U.S. NUCLEAR REGULATORY COMMISSION
 In the Matter of AmerGen Energy Co., LLC
 Docket No. 50-0219-12 Official Exhibit No. Citizens Exhibits
 OFFERED by: Applicant/Licensee Intervenor
 NRC Staff _____ Other _____
 IDENTIFIED on 9/20/07 Witness/Panel N/A
 Action Taken: ADMITTED REJECTED WITHDRAWN
 Reporter/Clerk _____

Memorandum

**Subject: Review of Fitness for Service Assessment of Oyster Creek Dry Well
on the Basis of Extended Data Analysis**

Figure 1

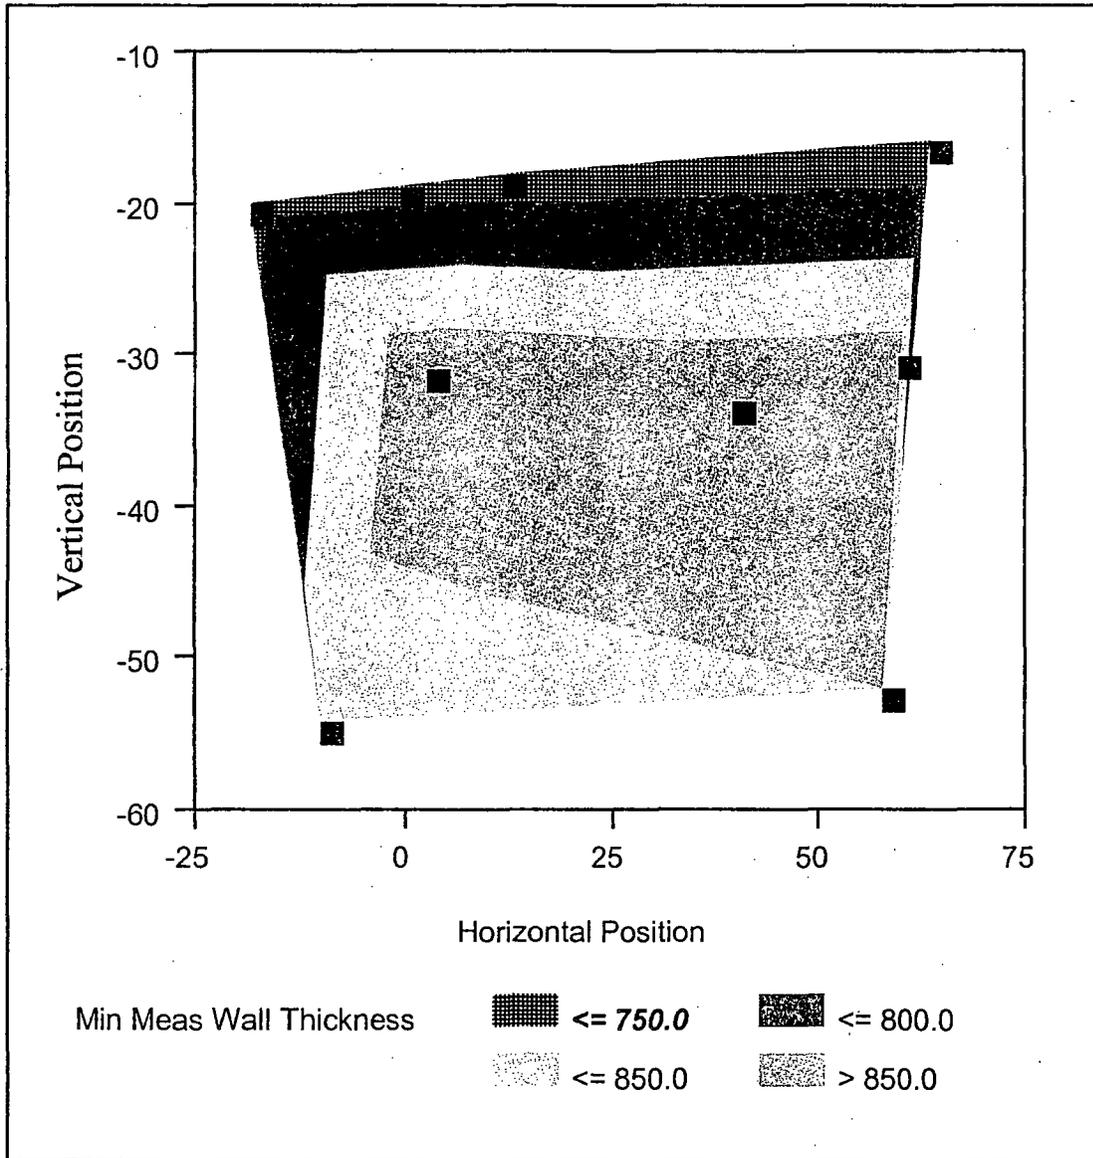
possible. However, we can look at the situation and gain intuitive insight into this question. Figure 1, which is discussed in detail below, presents areas of equal wall thickness (contours) based on the measurements, shown as the points, performed on the outside of Bay 19 in 2006. Note the dark squares are 2.5 inch on each side (and drawn to scale with reference to the horizontal axis), hence cover the area of measurement claimed by AmerGen. It turns out that the measurements at the -20 (inch) vertical position are on average less than 0.725 inches. Since measurements had not been extended to higher elevations one has no assurance that there are no more seriously corroded areas either between those measured or further up in the sandbed.

The advantage of this evaluation is that one can see all the available data in a quantitative presentation. Thus, one can see in Figure 1 that an area exists at elevation -20 (20 inches below the reference point) where the remaining wall thickness is less than 750 mils, or less than the criteria for general thinning at 95% confidence. This area extends from 20 inches on the left (-20 inches) to about 60 inches on the right (+60 inches), or about 7 feet. The width of this area in Fig. 1 is maybe 4 to 5 inches, however, because measurements were not extended toward lesser elevations (from the reference point) one simply cannot estimate how much further the serious the corrosion may extend in Bay 19.

Figure 1 mentioned previously shows a heavily corroded area in Bay 19 at elevation -20. The extent of this area is highly uncertain because it was not further defined by additional UT measurements toward higher elevations (>-20). Indeed, one could find here an extended bathtub ring area.

Figure 2
Bay 1 Remaining Wall thickness
External UT Measurements 1992/1993

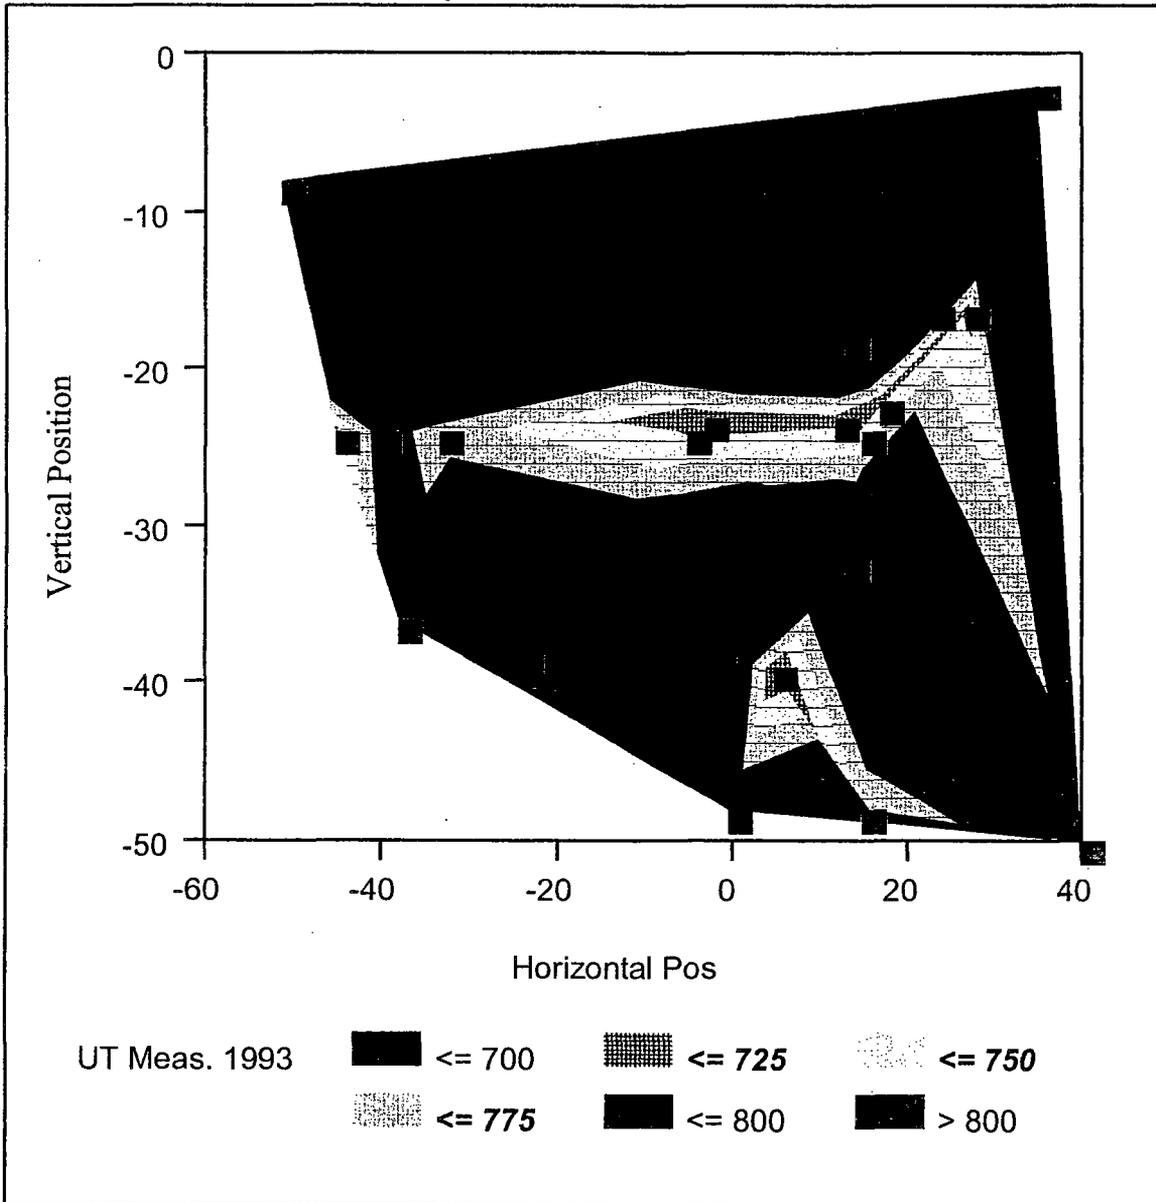
The data used for the analysis are contained in Tables 1 and 2 for Bays 1 and 13 as extracted from AmerGen documents. Presumably, these were the most corroded Bays. Figure 2 shows a contour plot for Bay 1 obtained with the data from 1992. The dimensions of the points in the plot are 2.5 by 2.5 inches. Again, one needs to remember that the specific shape of the contours depends not only on the residual wall thickness measured at the locations indicated, but on the density of measurements as well. (For instance, an additional measurement at coordinates h (-20) v (-25) could completely alter the contours and in all likelihood extend the area of wall thickness below -750 mils ⁴⁾).

Nevertheless, it appears in Figure 2 that in the so called “bathtub ring” an extensive area exists with wall thicknesses between 700 and 750 mils (0.75 inches). This area extends well over 52 inches (4+ feet) and is about 5 inches wide. In view of the fact that UT measurements are at best accurate with a standard deviation of about 45 mils, (95% confidence limits +/-90 mils), this area could well be more extensive.

Figure 3

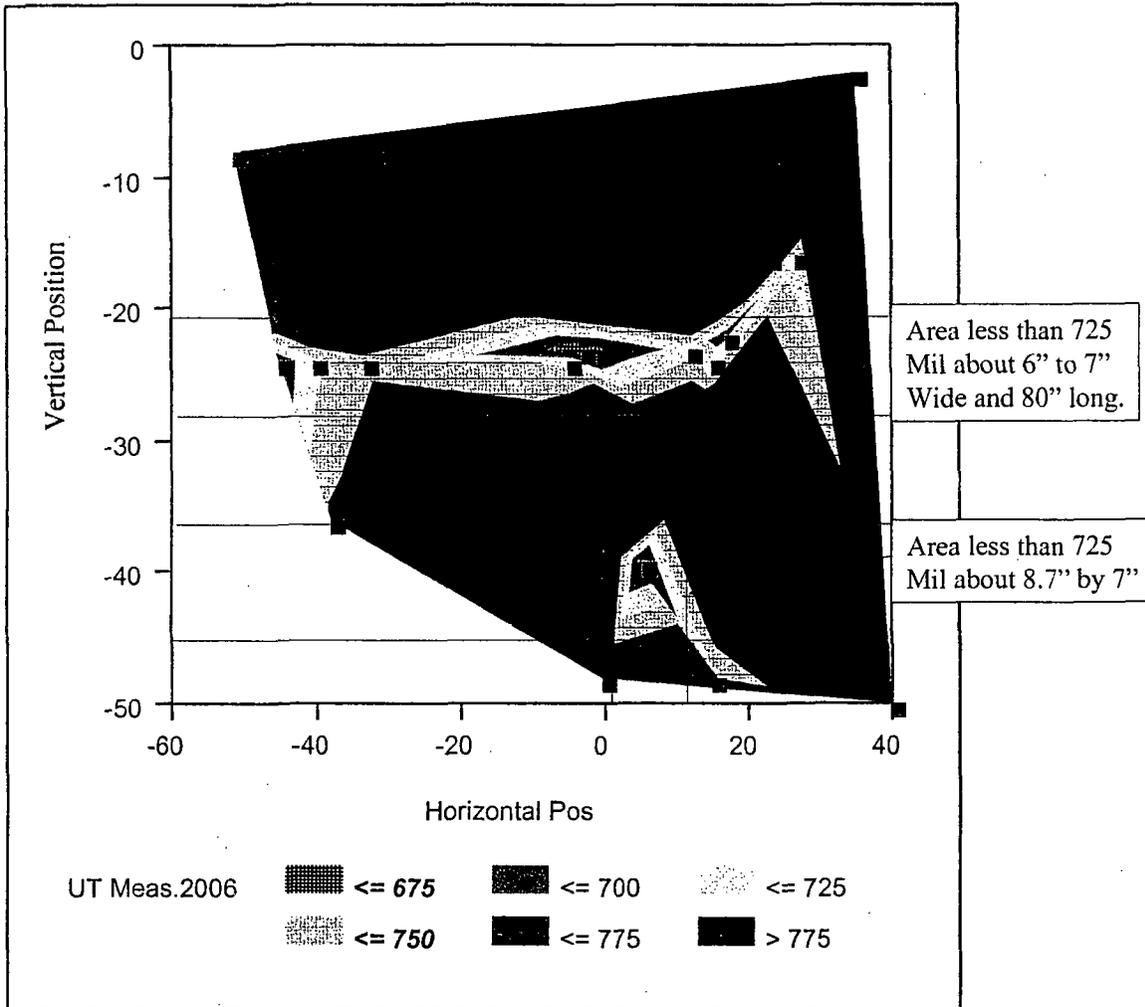
Figure 3 shows the contours for Bay 1 obtained with the data from the 2006 inspection. The general shapes are the same as in Figure 2 except that here we have sizeable areas with residual wall thicknesses below 725 mils. The unexpected thing is

that these areas seem to extend on the left beyond h -40 inches but no measurements are available to verify whether AmerGen did in fact manage to capture all of the most corroded areas as claimed.

Based on Figure 3, together with an assessment of the accuracy (reliability) of the data one must conclude that there is a good likelihood that the entire bathtub ring area extending from 40 to -40 inches on the horizontal axis and from about -30 to perhaps -20 inches on the vertical axis is below the 0.736 inch criteria for general thinning and is, much larger than the one square foot acceptance criterion. (Of course, since this area is the most corroded, it will taper off to higher wall thickness on both sides of the vertical axis). The corroded area is indeed shaped quite irregular, but one could venture a guess that the contoured areas below 750 mils are of the order of 4 to 7 square feet all together. This estimated area does not include the area to the left of -40, which probably contains additional area below 0.750 inches.

Figure 4

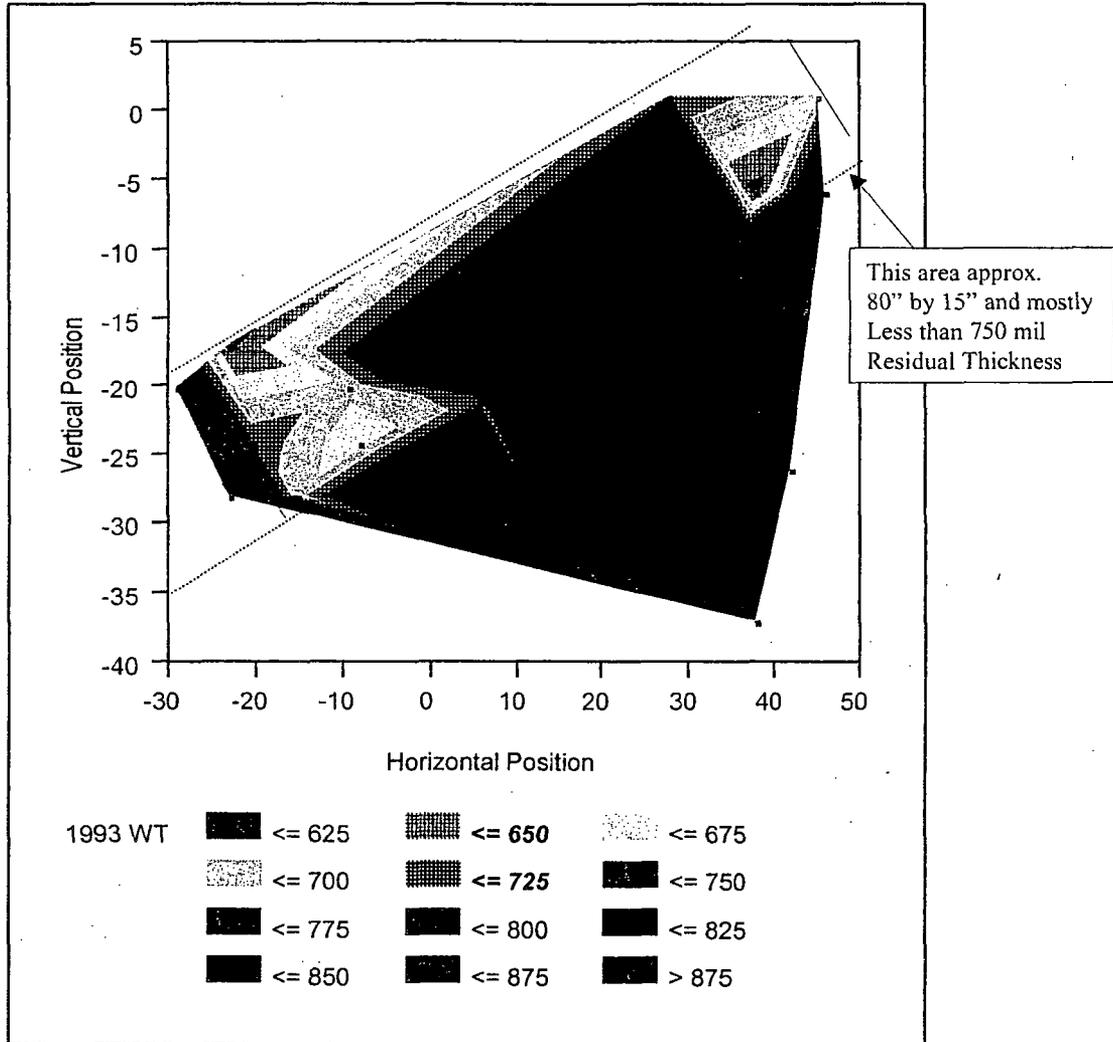
Figures 4 and 5 show the contours for Bay 13, 1992 and 2006 data, respectively. Here large areas exist with wall thicknesses below 700 mils and at least two seemingly unconnected areas where the residual wall thickness is less than 650 mils. It could be argued that those heavily corroded areas are less than 1 square foot and therefore are still acceptable according to the 636 mil criterion. However, the heavily corroded area on the left hand side (-20, -20) has not been further explored. One therefore does not know whether it might extend further. Similarly, the area on the right ((40, -7), clearly showing a fairly deep pit, was not further explored and was not even measured in 2006. While in Bay 1 the bathtub ring was at elevation -20 to -25 (from the reference point) in Bay 13 there is no clearly prominent bathtub ring. This may be because it was not there, but it may also be because the measurements were not extended toward elevation -15 and -10. We are therefore left with a great uncertainty as to the true extension of the damage in this Bay.

- If an area is less than 0.736 inches thick then that area shall be greater than 0.693 inches thick, and shall be no larger than 6 inches by 6 inches. C-1302-187-5320-024 has previously placed an area of this magnitude in Bay 13 (Ref.2) ⁵⁾ Actually, as can be seen from Figure 4, there are two such areas in Bay 13.
- Most recently, the limiting wall thickness criterion was formulated as follows: *An evaluated area for local buckling shall not be greater than 36 inches by 36 inches wide. The center of the area shall be no larger than 12*

Figure 6

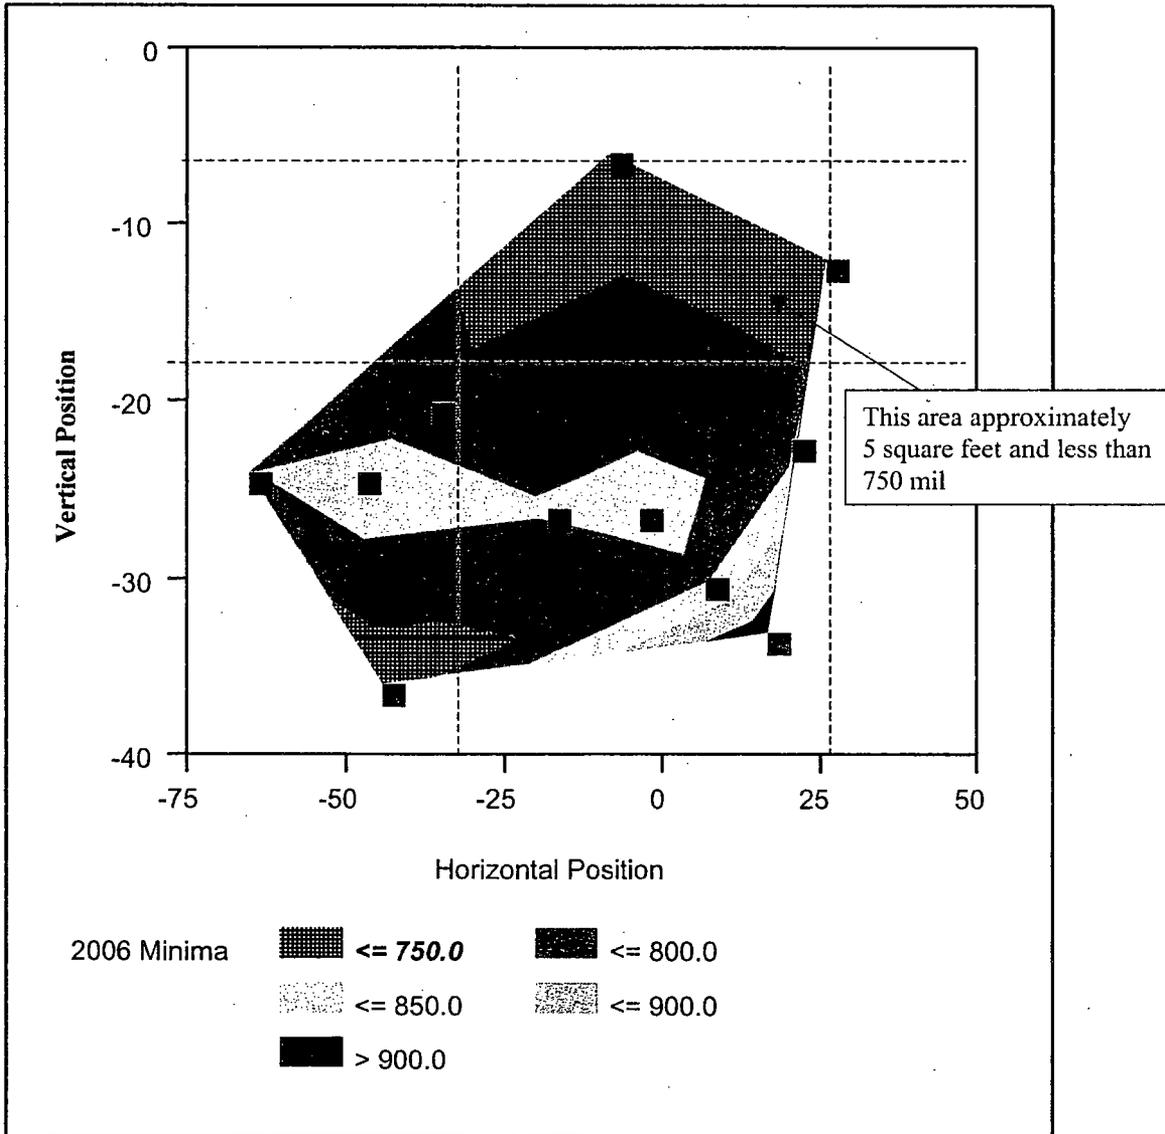
Figure 6 shows the contours for Bay 15. There is a heavily corroded area at elevation -10 with an extension of 1 ft by about 4.5 feet. However, this area was explored only with 2 measurements and was not extended beyond about 2 feet either side of the centerline. It appears that the majority of the measurements occurred in the non-corroded zones. Interestingly there appears some serious corrosion near the sandbed bottom, but the occurrence was not further explored either.

Figure 7
Contour Plot for External UT 1992 Data Bay 11

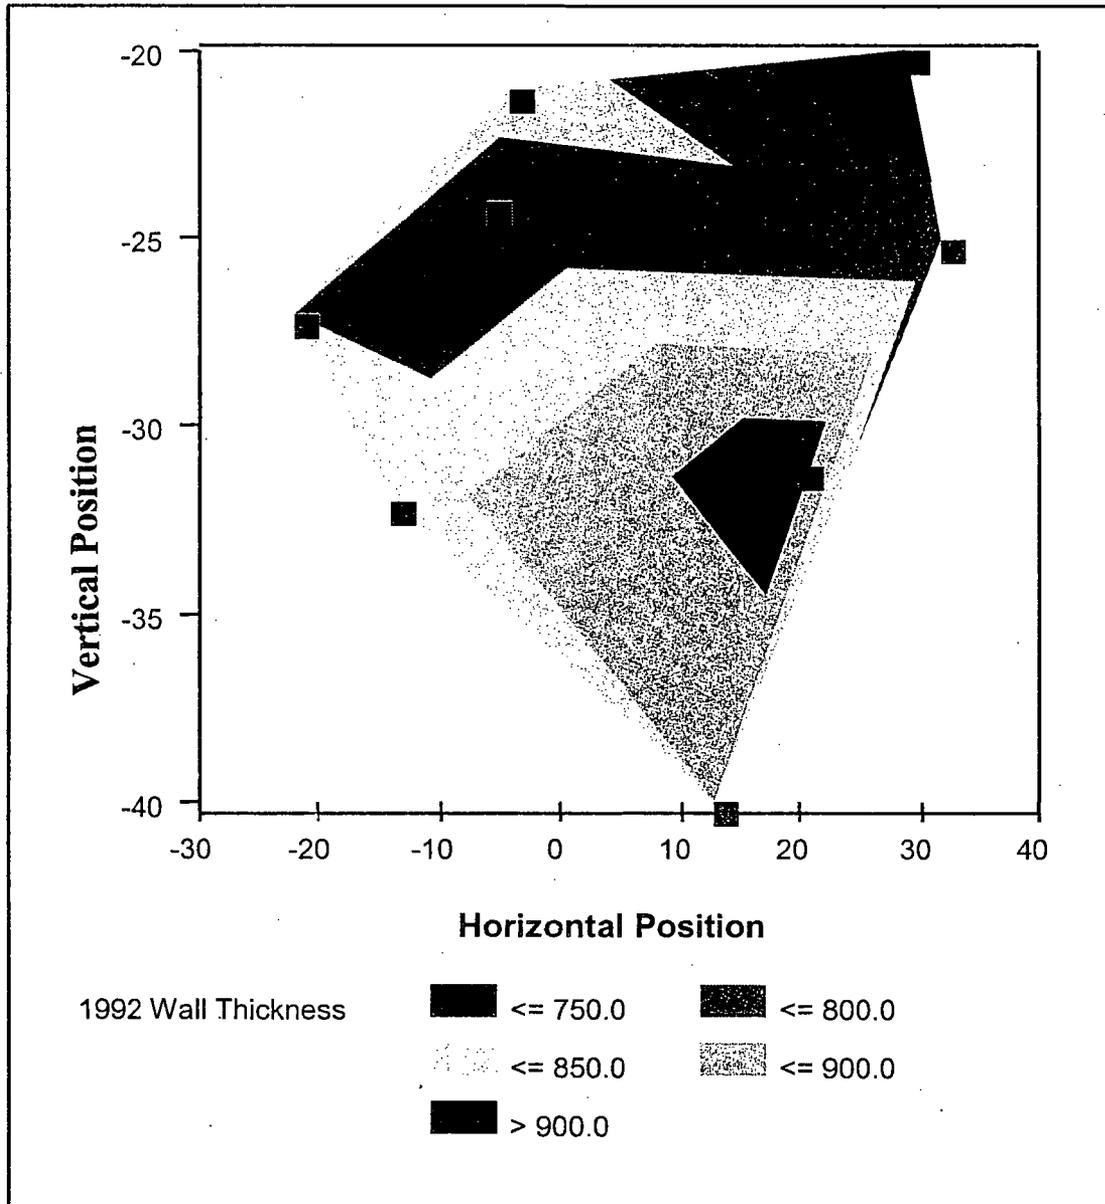
Figure 7 shows the contours for Bay 11. Again there is a suggestion of severe corrosion at elevation -20 and no further exploration into the bathtub ring area. Once again, the extent of this area is highly uncertain because it was not further defined by additional UT measurements.
